File SPR-1996-107

Name: Safeway – SE Corner of 29 Road – Site Plan Review

SITE PLAN REVIEW ~~# Mesa Subdivision~~

Figure 9-5 Intersection pavement markings - designated bicycle lane with left turn area, heavy turn volumes, one-way traffic or divided roadway.

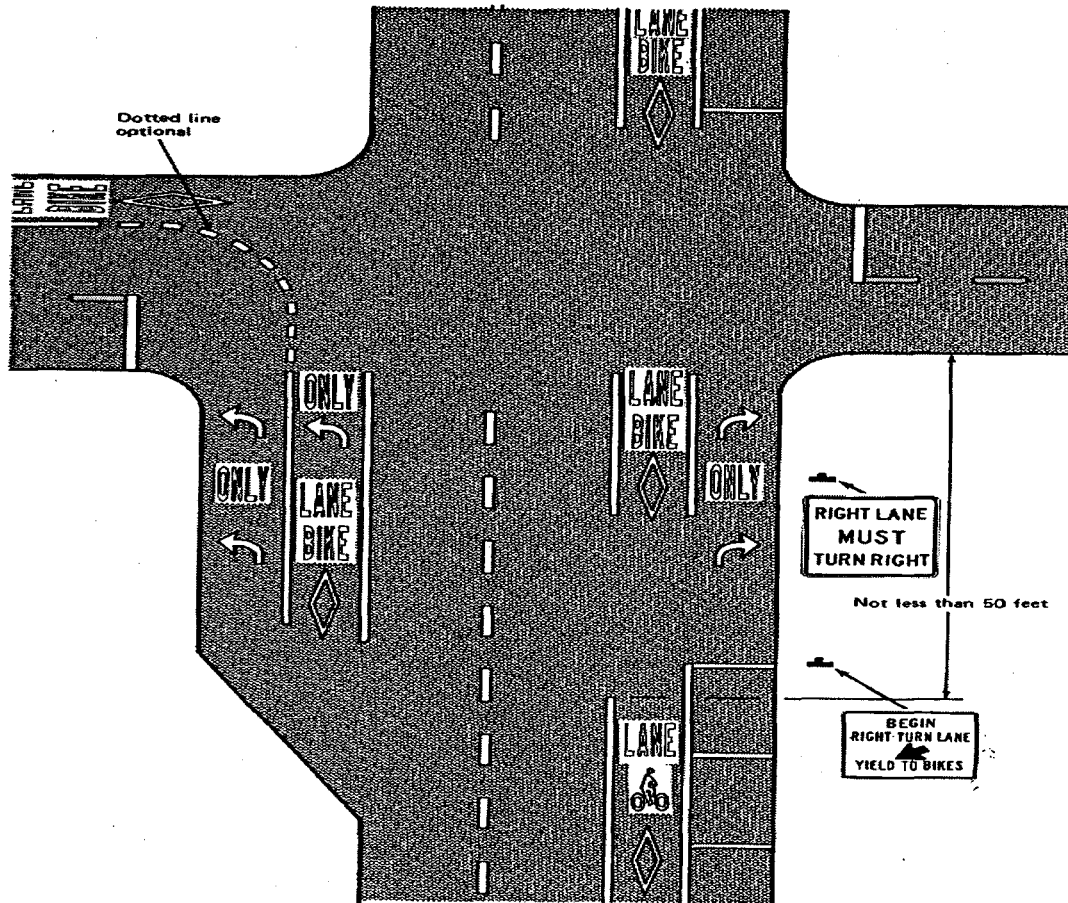
5. The bike lane on 29 Road will be required to be striped for through bicycle traffic rather than as shown on the plan. This modification will also require installation of a bicycle detection loop and installation of a new quadropole loop detector in the right turn lane. the striping change should be made in accordance with the figure below. A copy of details for loop and conduit installation is attached with these comments.

SHEET 1 OF 2

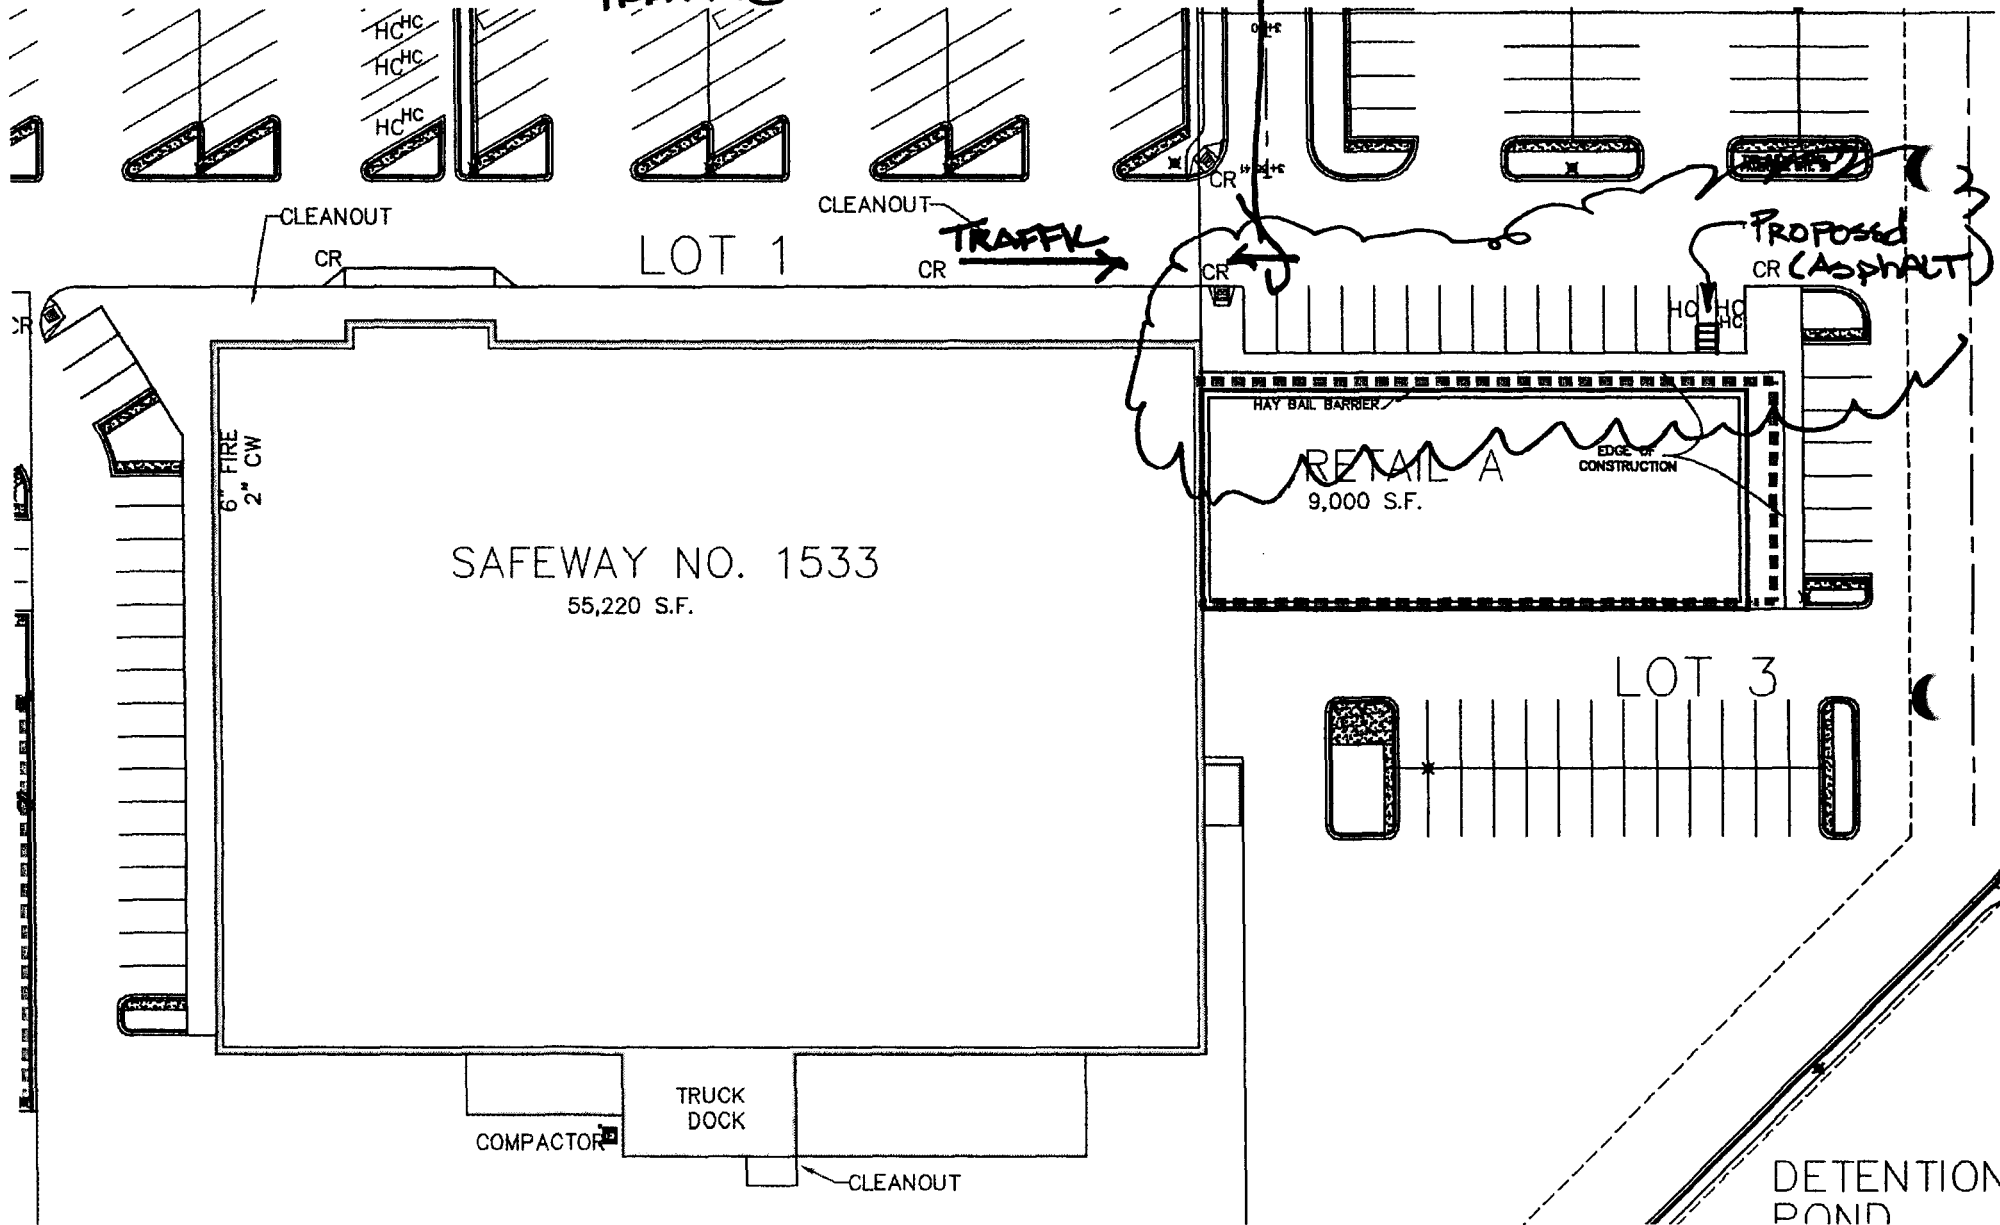
TO USE THIS HC RAMP
WHEEL CHAIRS WOULD BE
DIRECTED INTO VEHICLE
TRAFFIC
